Access Compliance Report

Public Rights-of-Way

(Curb Ramps)

Intersection ID: 31490	Main Street: BULLOCK_DR	Cross Street: CLOVER_GAP_DR	Location:	N
ADA ID: E22DC2217599	Ramp Type: PerpDiag	Initial Pass/Fail: Fail	Overall Compliance: No	Severity Score: 8.75

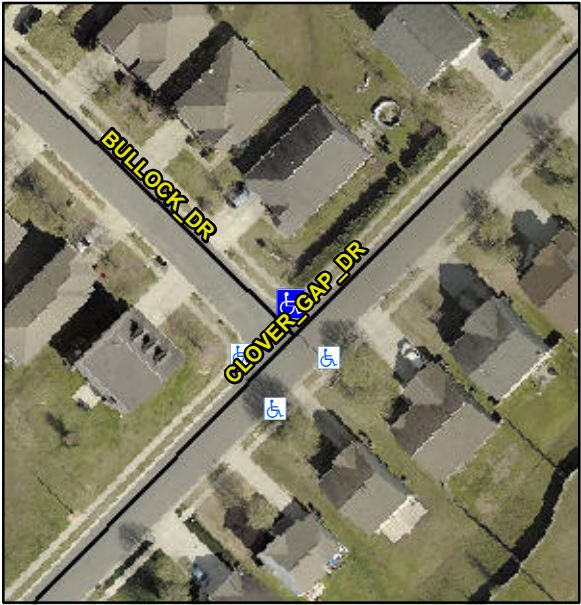
Codes/Mitigation Info/Possible Solution			Field Measurements/Component Compliance		
	Possible Solutions:		Compliance	Description	Data
	Remove & Replace Curb Ramp With Two New Directional Ramps or Equivalent.		N/A	Ramp Length (in)	49.0
			No	Ramp Width (in)	45.5
			N/A	Flare Type LT	N/A
			N/A	Flare Slope LT (%)	N/A
			N/A	Flare Traversable LT?	N/A
			N/A	Landing Length (in)	N/A
			N/A	Landing Width (in)	N/A
			N/A	Landing Slope (%)	N/A
			N/A	Landing X Slope (%)	N/A
<p>Surveyor Notes:</p> <p>N/A</p> <p>PROW/ADA:</p> <p>Not Found, R304.5.1</p>			N/A	Flare Type RT	N/A
			N/A	Flare Slope RT (%)	N/A
			N/A	Flare Traversable RT?	N/A
			N/A	DWS Provided?	N/A
			N/A	DWS Contrast?	N/A
			N/A	DWS Length (in)	N/A
			N/A	DWS Full Width?	N/A
			N/A	DWS Offset (in)	N/A
			N/A	Shared Landing?	N/A
			N/A	Gutter Ponding?	N/A
			N/A	Gutter Lip Ht (in)	N/A
			N/A	Painted X Walk1?	No
				X Walk 1 Direction	To SW
			N/A	X Walk 1 Width (in)	N/A

X Walk 1 Slope (%)	1.5
				X Walk 1 X Slope (%)	2.1
			N/A	Ramp inside XWalk1?	N/A
				Road Slope (%)	0.6
				Road X Slope (%)	3.5
			N/A	Any Obstructions?	N/A
				Obstruction Type	
Total Cost:			\$	3200.00
